# Conceptual Site Plan Amendment Detailed Site Plan

**CSP-06003**  
**DSP-17023**

STAFF REPORT

SUBJECT: Conceptual Site Plan Amendment CSP-06003  
Detailed Site Plan DSP-17023  
Type 2 Tree Conservation Plan TCP2-007-2016-01  
Addison Row, Phase 1  
Expedited Transit-Oriented Development Project

# BUILDING MOUNTED SIGN

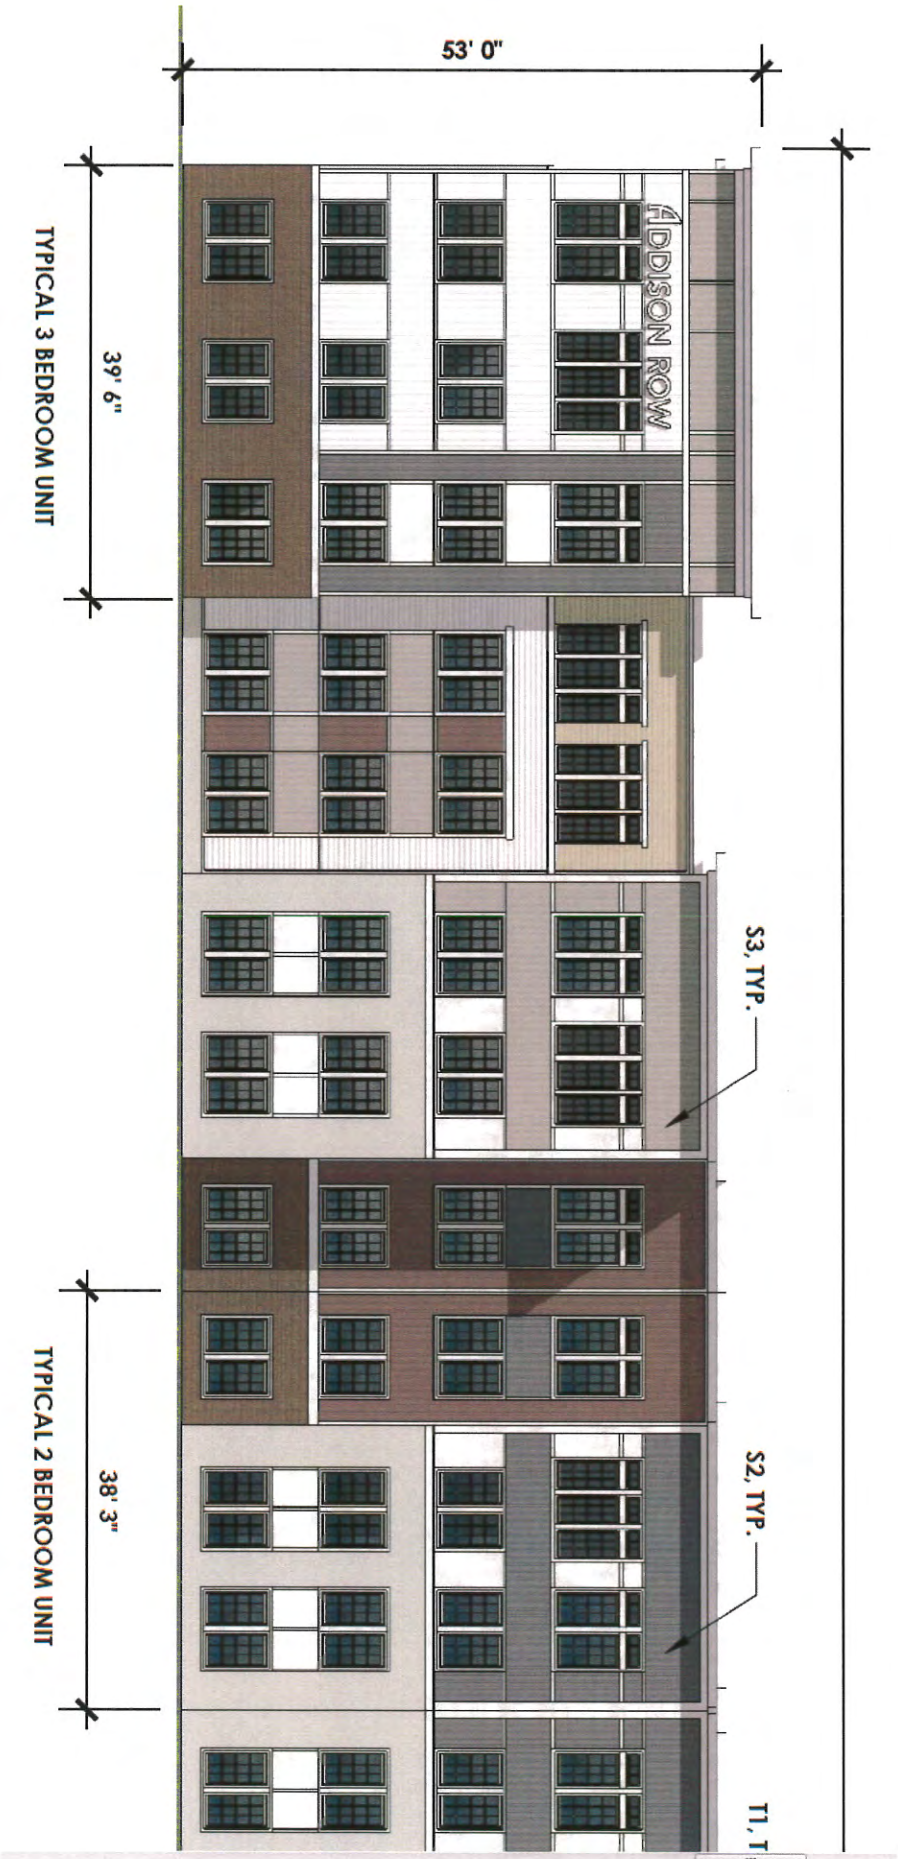
The DSP proposes building-mounted signs to be placed on the tower element of the elevations fronting on Addison Road. The signage is acceptable. However, no dimensions or details are provided. A condition has been included in the Recommendation section of this report requiring the applicant to provide the sign details, face area, and dimensions prior to certification.
